Transport
for NSW

Western Distributor Network Improvements

Review of Environmental Factors
Submissions Report
July 2023

Figure 4-1: Design refinements of the proposal

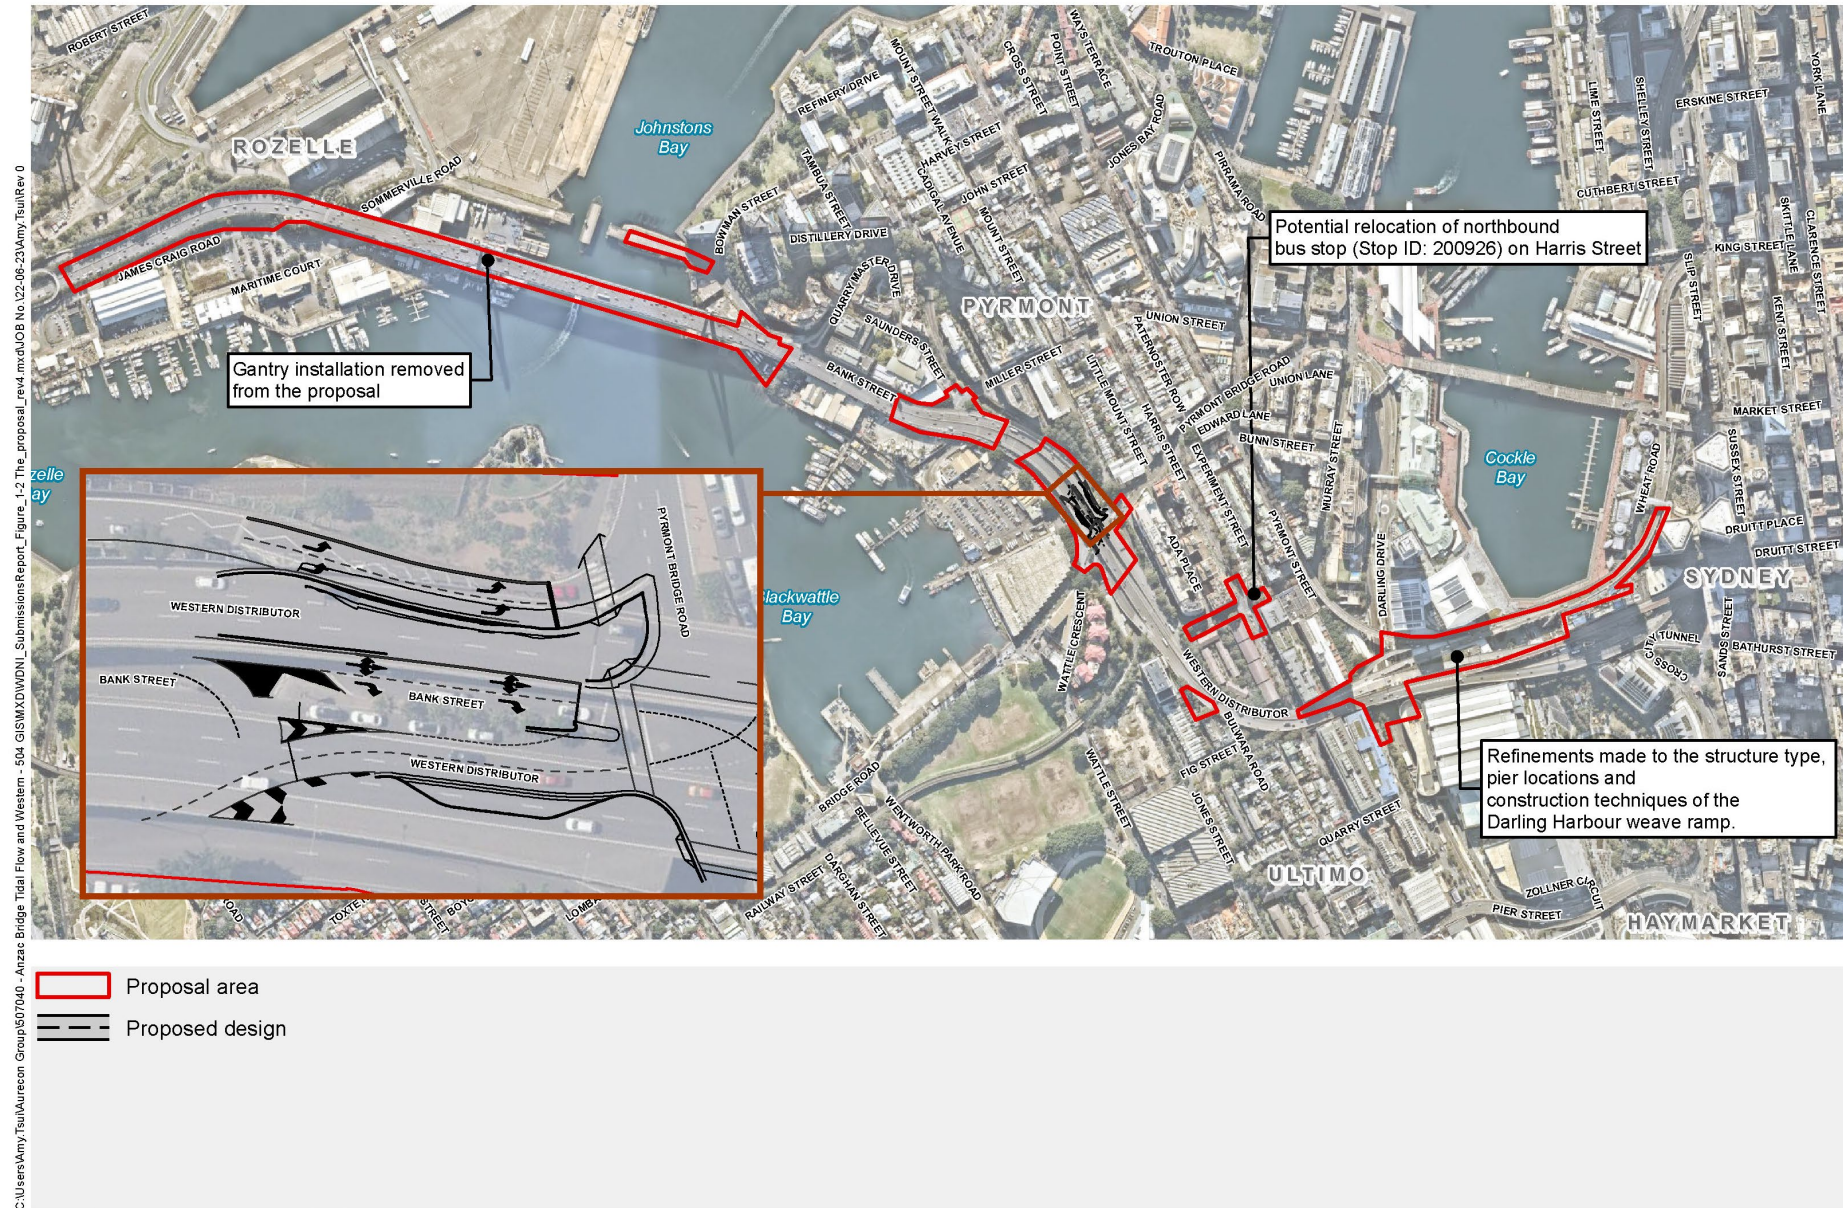
Following exhibition of the REF, the proposal design has been refined in response to stakeholder feedback and further progression of the design, including to allow for construction efficiencies.

The design refinements to the proposal are detailed in the following sections and shown in Figure 4-1. All refinements are within the existing proposal area as defined in the REF.

Figure 4-2: Comparison of the REF design and design refinement to the alignment of the Darling Harbour weave ramp

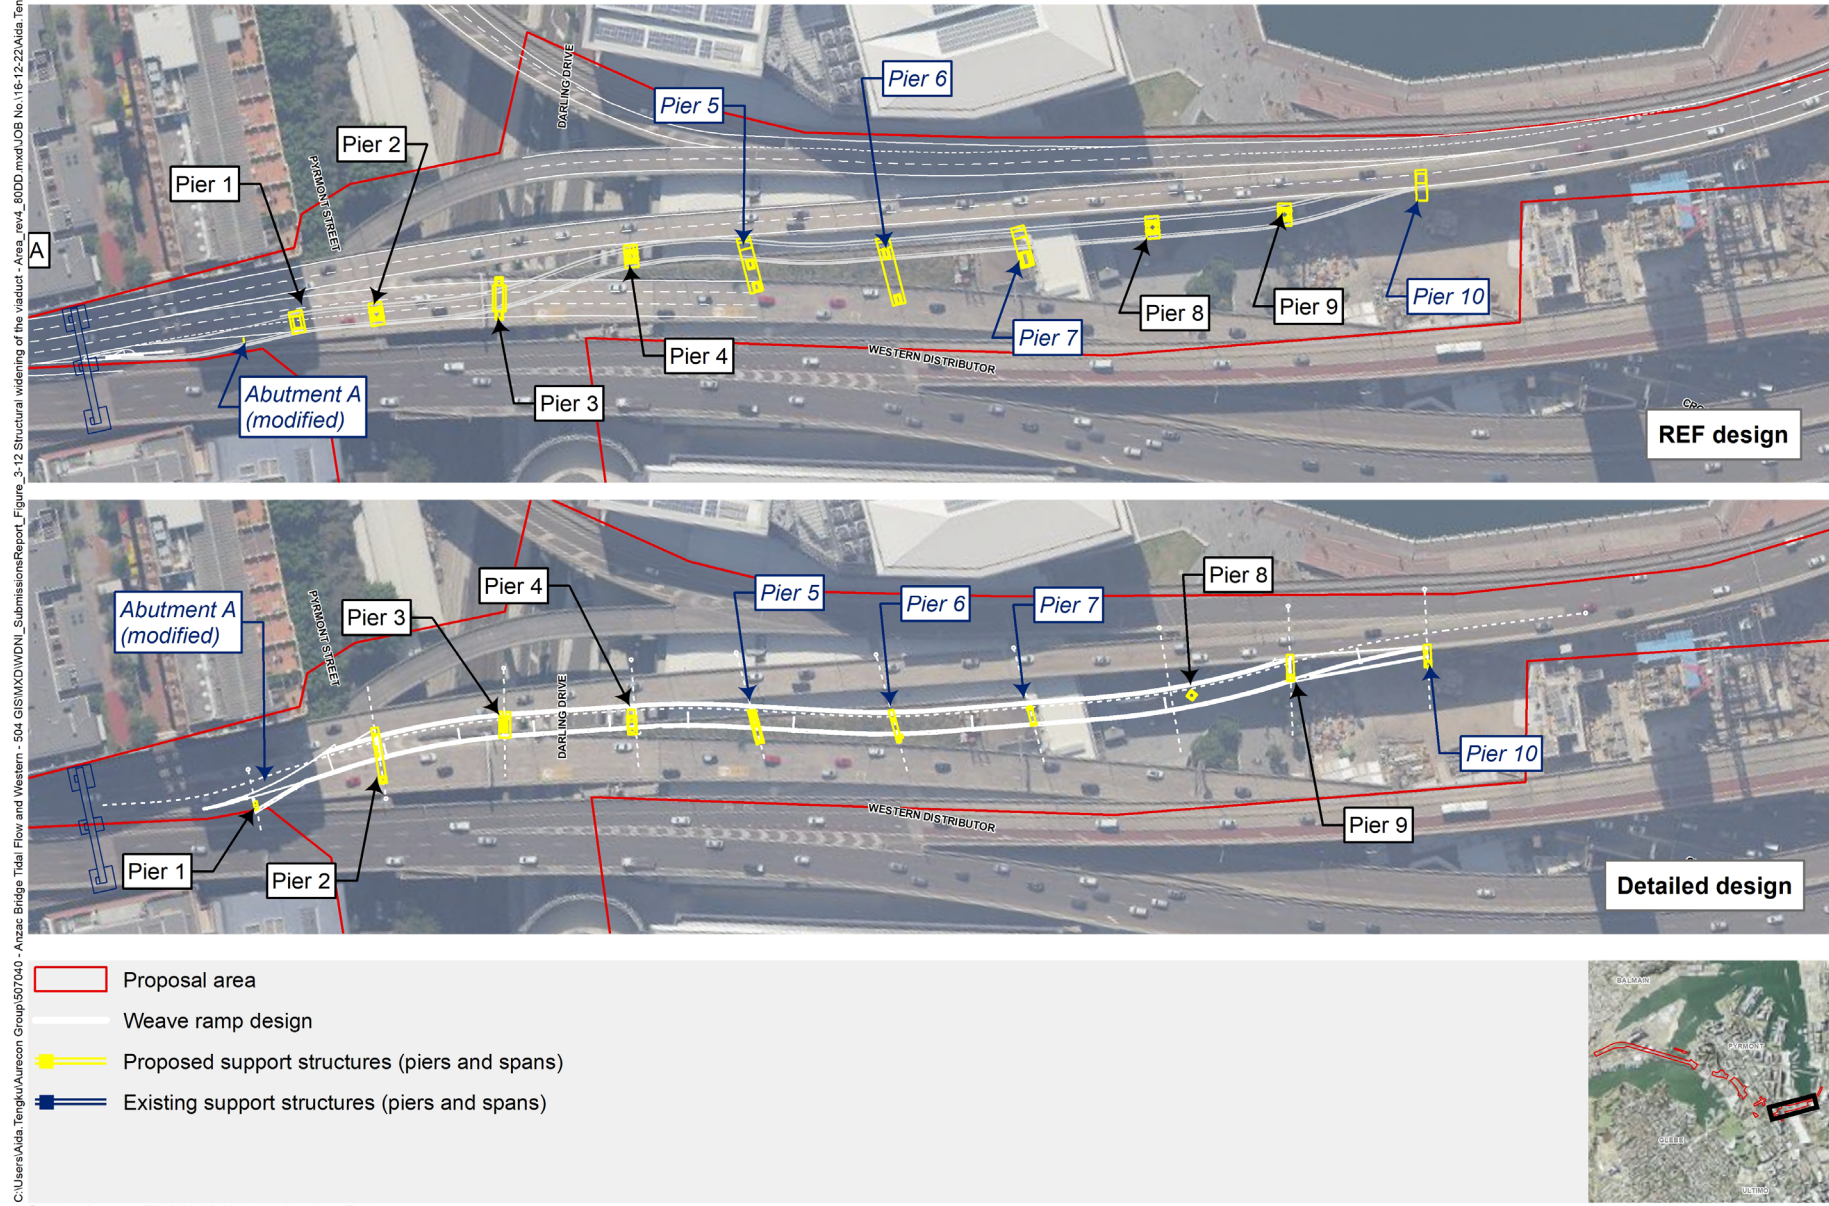
Further design development has resulted in a number of changes to the design and confirmation of details of the construction methodology that were not available in the REF.

Figure 4-4: Proposed parking restrictions – Harris Street

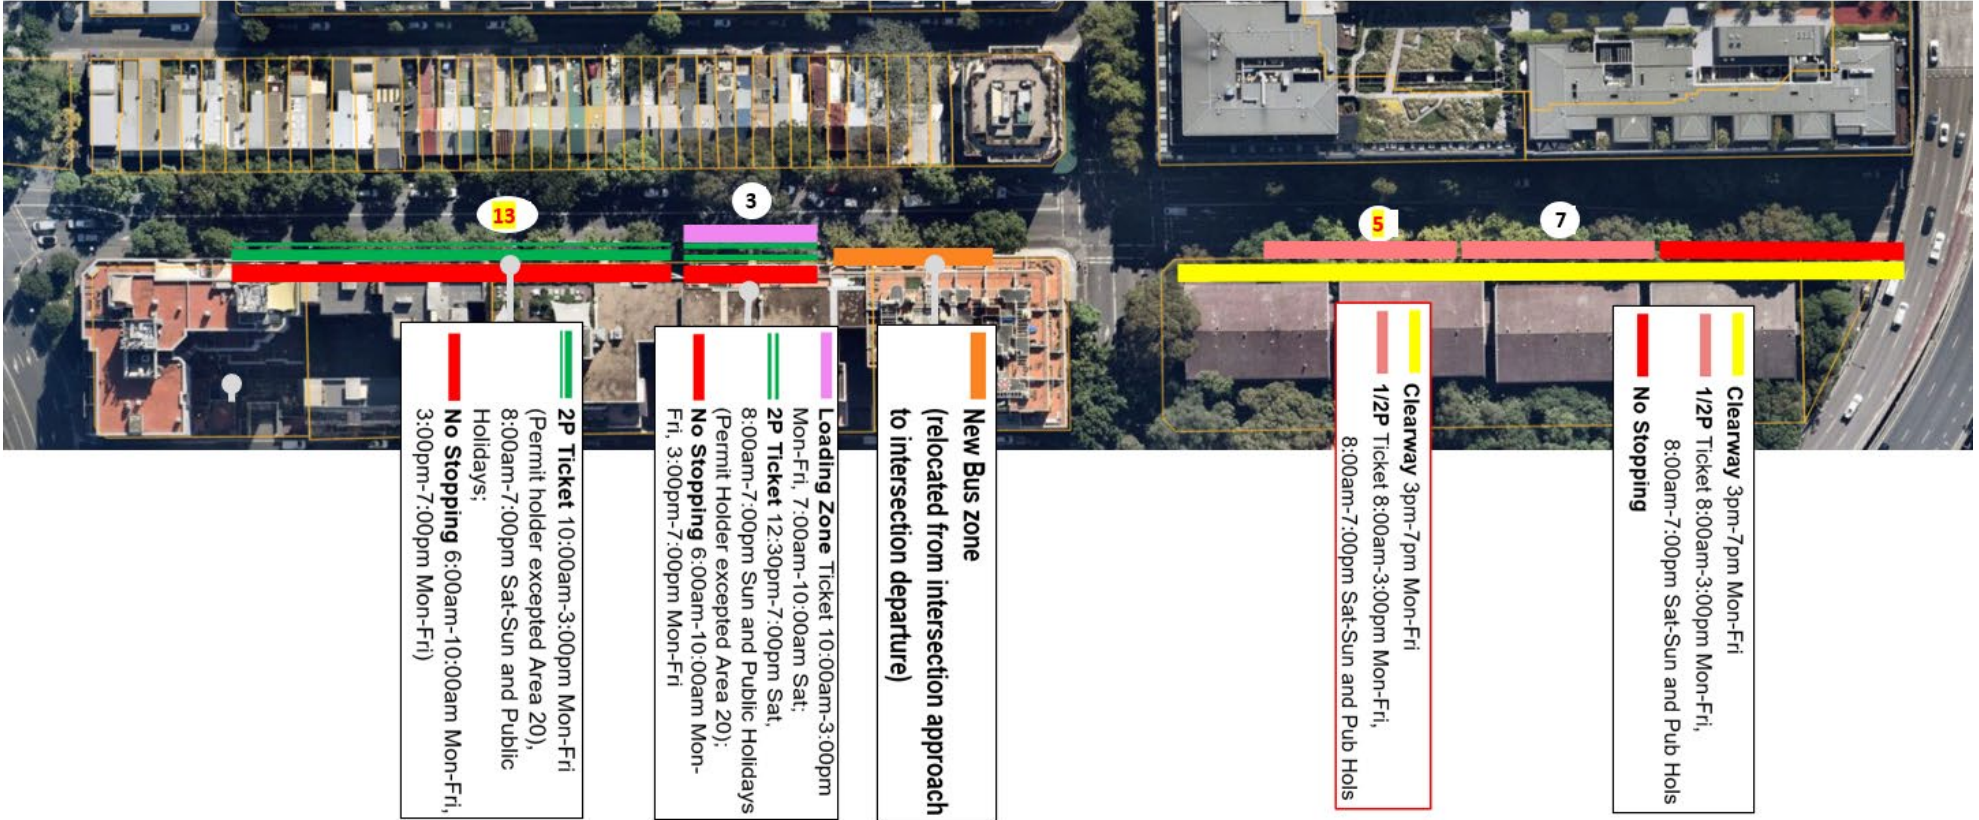
On Harris Street northbound between Allen Street and Pyrmont Bridge Road, the existing loading zone would be retained and shifted further north on Harris Street northbound. To accommodate the loading zone and bus stop, there would be a loss of six '2P' parking spaces with parking exemptions for residents in the City of Sydney Pyrmont and Ultimo parking area (Area 20)¹ (reduction from 19 to 13 spaces as shown in Figure 4-4).

Where the existing bus stop would be removed south of Allen Street, five new '1/2P' parking spaces would be created (refer to Figure 4-4). The seven existing parking spaces between Fig Street and Allen Street would be retained.

Further targeted consultation would occur with the local community regarding this change.
